## ***City of El Paso – City Plan Commission Staff Report***

**Case No:** SUSU15-00081 Sierra del Puerte Unit 4  
**Application Type:** Major Combination  
**CPC Hearing Date:** March 10, 2016  
**Staff Planner:** Joaquin Rodriguez, (915) 212-1608  
[rodriguezjx3@elpasotexas.gov](mailto:rodriguezjx3@elpasotexas.gov)  
**Location:** South of Hondo Pass and West of Dyer  
**Acreage:** 16.182 acre  
**Rep District:** 4  
**Existing Use:** Vacant  
**Existing Zoning:** PMD (Planned Mountain Development)  
**Proposed Zoning:** PMD (Planned Mountain Development)  
**Nearest Park:** Sunrise Park (.52 miles)  
**Nearest School:** Park Elementary(.48 miles)  
**Park Fees Required:** N/A  
**Impact Fee Area:** N/A  
**Property Owner:** GCGOHL, LLC  
**Applicant:** GCGOHL, LLC  
**Representative:** Roe Engineering

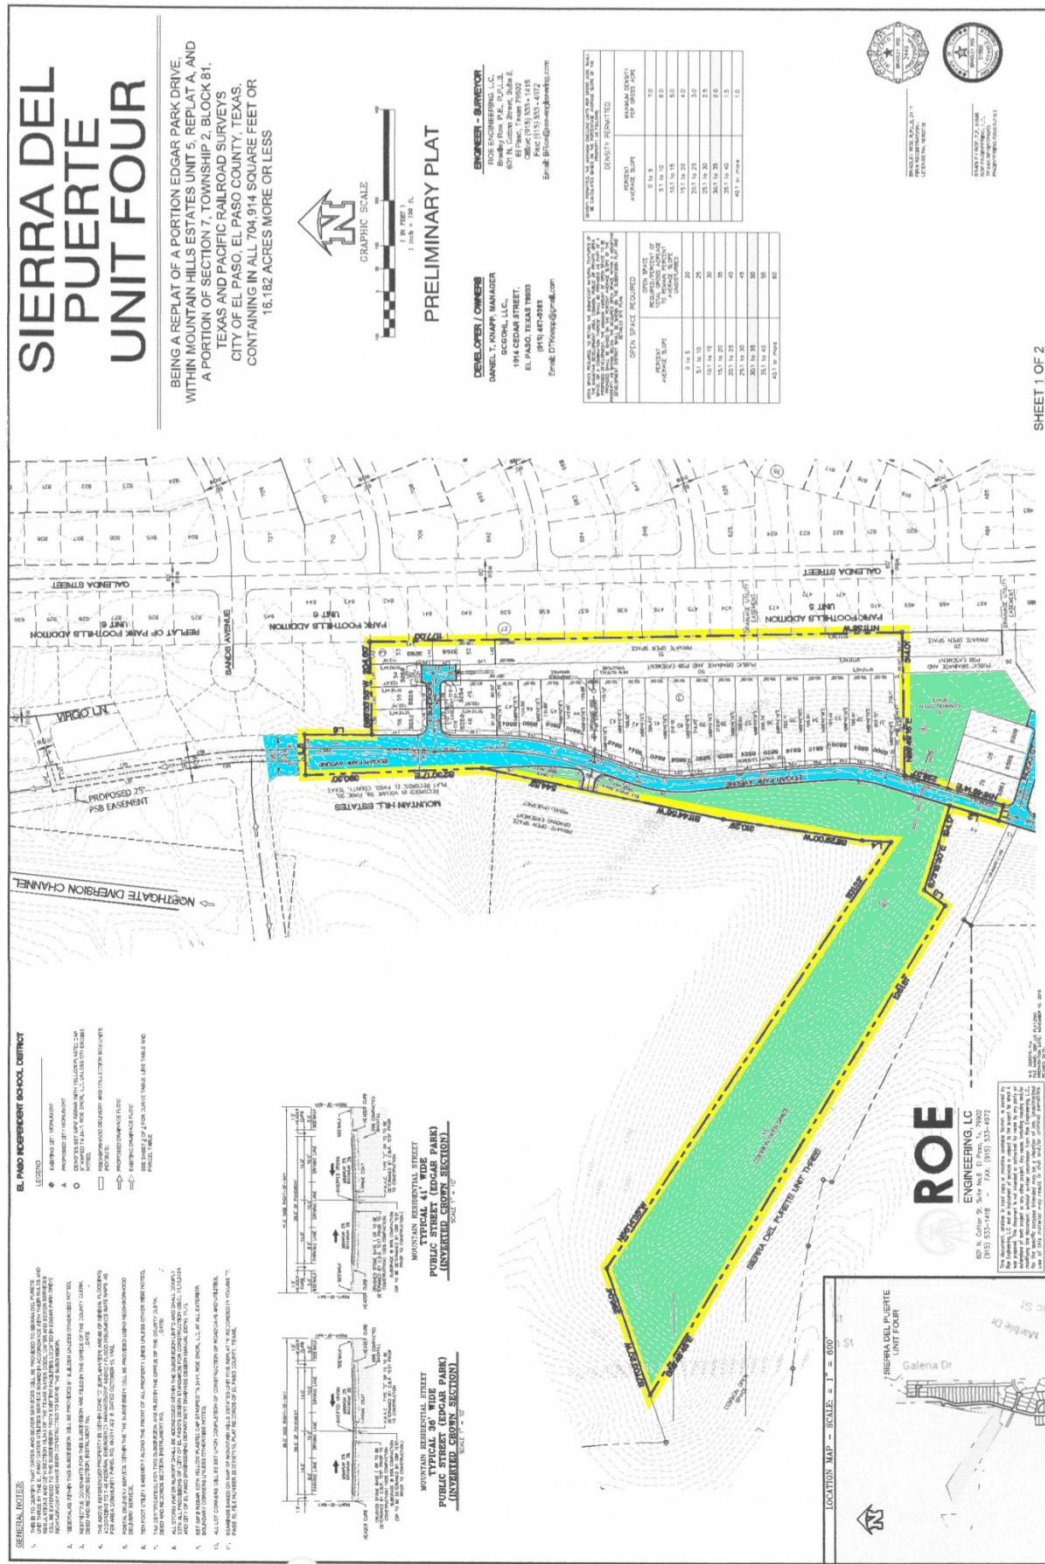
1. The recording of the Sierra del Puerte Unit 4 will be subject to prior recording of Sierra del Puerte Unit 2 to provide vehicular access; and Sierra del Puerte Unit 3 to provide water and sanitary sewer service.
2. The applicant will reconfigure the cul-de-sac at Sunfire Ct to match the requirements of the DSC for mountain development to minimize the impact of grading and paving on mountain areas.

3. The applicant will reconfigure the cul-de-sac at Sunfire Ct to match the requirements of the DSC for mountain development to minimize the impact of grading and paving on mountain areas.

7. The mountain residential street cross-sections show the inverted crown design. This type of design requires the use of a valley gutter at the lowest point; please refer to Detail 3-12 of COEP Design Standards for Construction.

9. Label or annotate entity responsible for maintenance of stormwater system crossing Edgar Park Ave. through common open spaces Lots 15, Block 5 and Lot 30, Block 30.

The district recommends that the proposed street, Sundrops Ct be changed to something else. There currently exists a street named Sundrop Ct. Thank you.

# ATTACHMENT 4

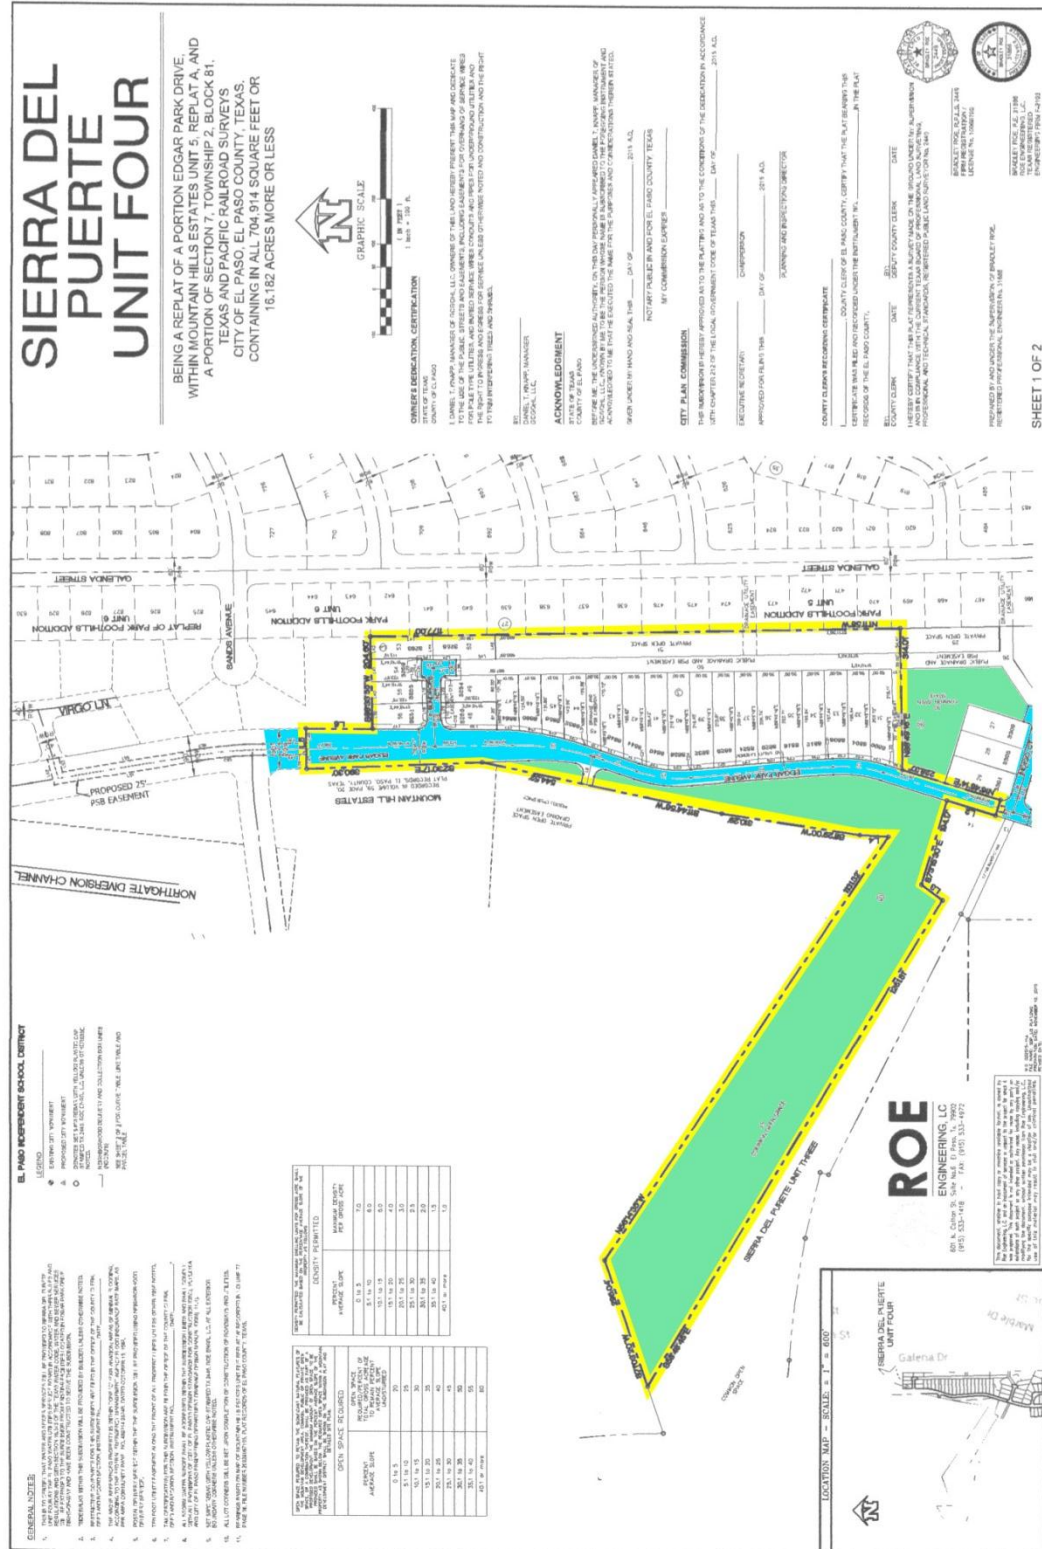
1. A 408 permit should be submitted to the USACE thru EPWU Stormwater Engineering to modify the structure or capacity of the channel.
2. All proposed City monuments shall be illustrated on the final plat.

3. Remove note 8 from general notes since it does not apply anymore.
4. Clarify private open space grading easement. No grading within private open space.

5. Verify dedication statement to include all easement types being dedicated on final plat.
6. The proposed subdivision is located near a high sediment/debris flow source with high flows and velocities. Any run-off from the mountain crossing under Edgar Park Ave. shall be handled through box culverts or with the use of bridges as stated in the Land study. The Engineer should account for sediment volume in all calculations used to size storm water drainage structures to prevent sediment from clogging the proposed crossings. Provide sufficient access for mechanized maintenance equipment and vehicles.
